Product / Process Change Notification (PCN)

| <p>PCN #: PCN_IndTIS_20220729</p> <p>Affected Series: WE-TIS; 7447471xxx</p> <p>PCN Date: April 29, 2022</p> <p>Effective Date: July 29, 2022</p> | <p>Change Category:</p> <p><input checked="" type="checkbox"/> Equipment / Location <input type="checkbox"/> General Data <input type="checkbox"/> Material <input type="checkbox"/> Process <input type="checkbox"/> Product Design <input checked="" type="checkbox"/> Shipping / Packaging <input type="checkbox"/> Supplier <input type="checkbox"/> Software</p> |

Description and purpose of change:
 There will be two changes for the articles 7447471013, 7447471022 and 7447471033 of the product series WE-TIS.

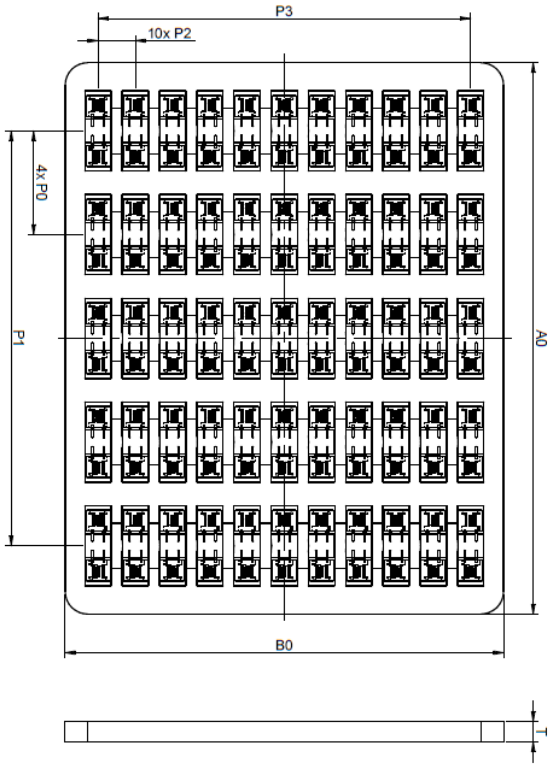
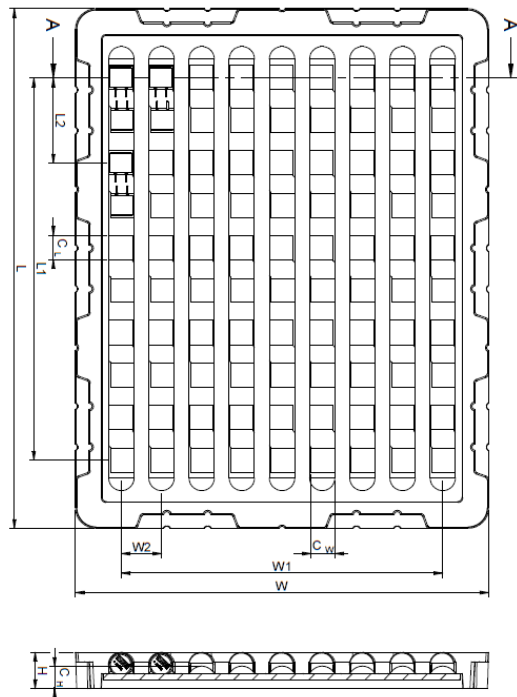
- To increase the production capability, Würth Elektronik will move the production to a new production site.
- Due to packaging optimizations, Würth Elektronik will change the tray packaging type.

All products with date code 2022-07-29 or later, will be affected by these changes.
 There will be no change in form, fit, function, quality or reliability of the product.

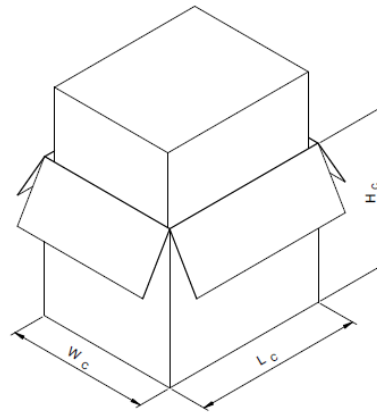
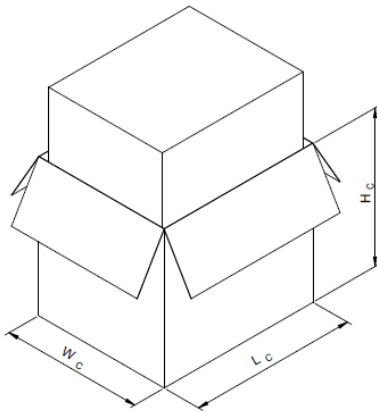
2. Details about the packaging change can be seen below
